ANGEL PLACE
LEVEL 8, 123 PITT STREET
SYDNEY NSW 2000

26 April 2019

CHATSWOOD CHASE DA 2017/503 - SNPP REQUEST FOR INFORMATION

APPENDIX A – AMENDED DESIGN REPORT & PLANS

1:100 @A1 0 2 4 6 8 10m

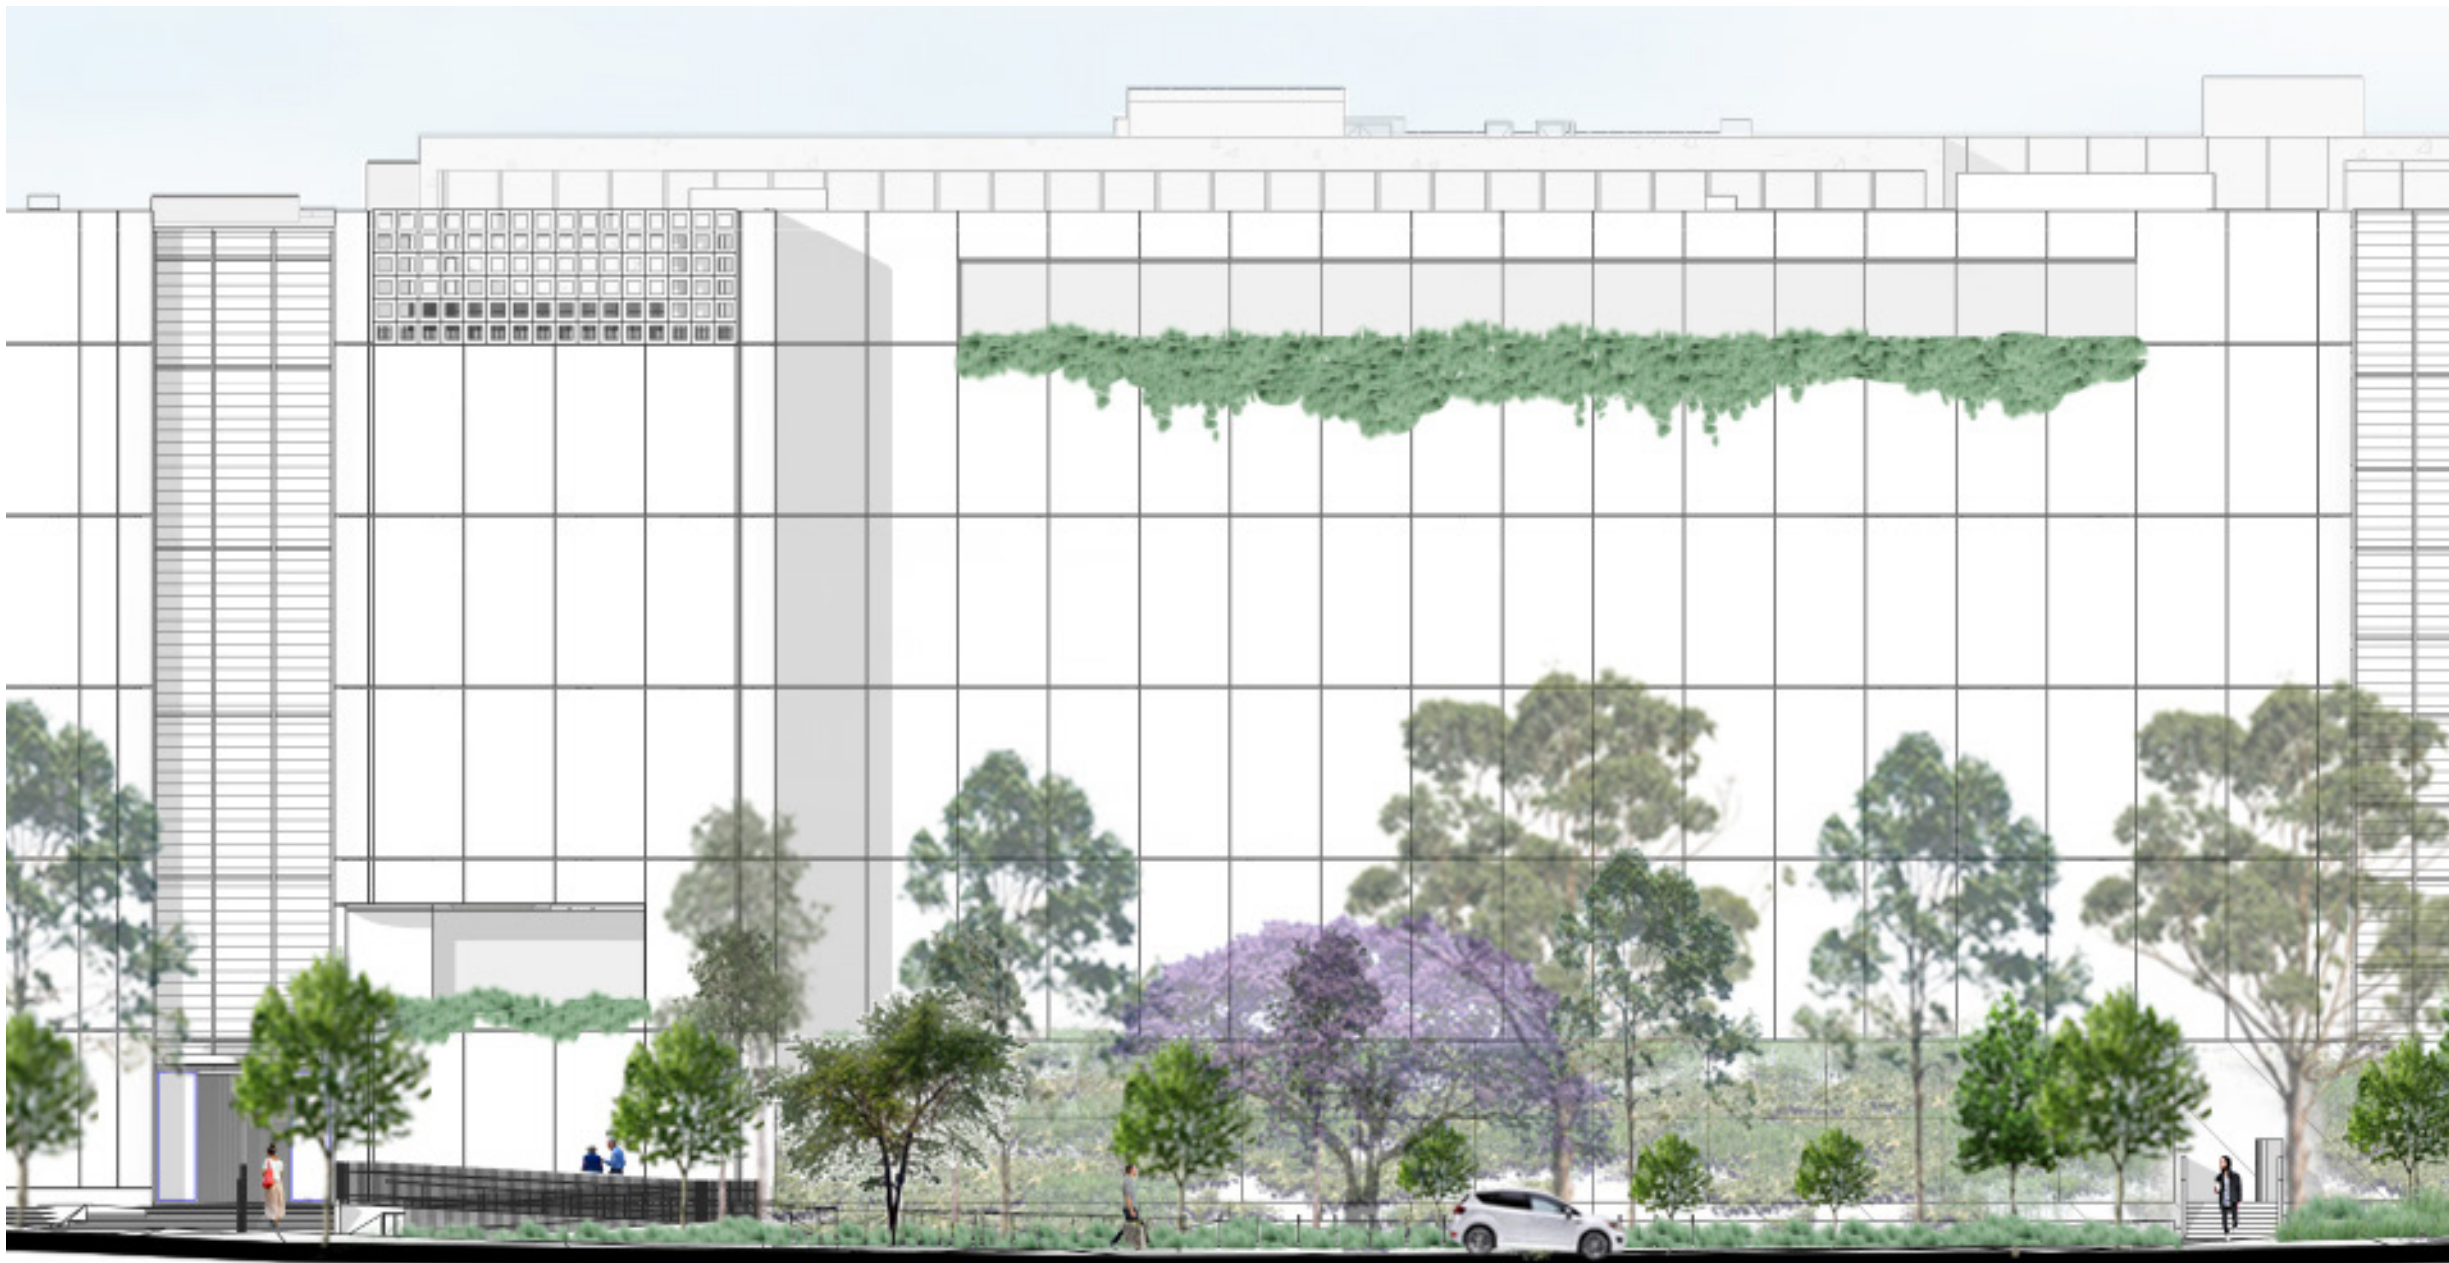
- Revised landscape detail by Lat27 at **Appendix B** that clarifies the species of trees and general greening of development along the Havilah Street frontage.
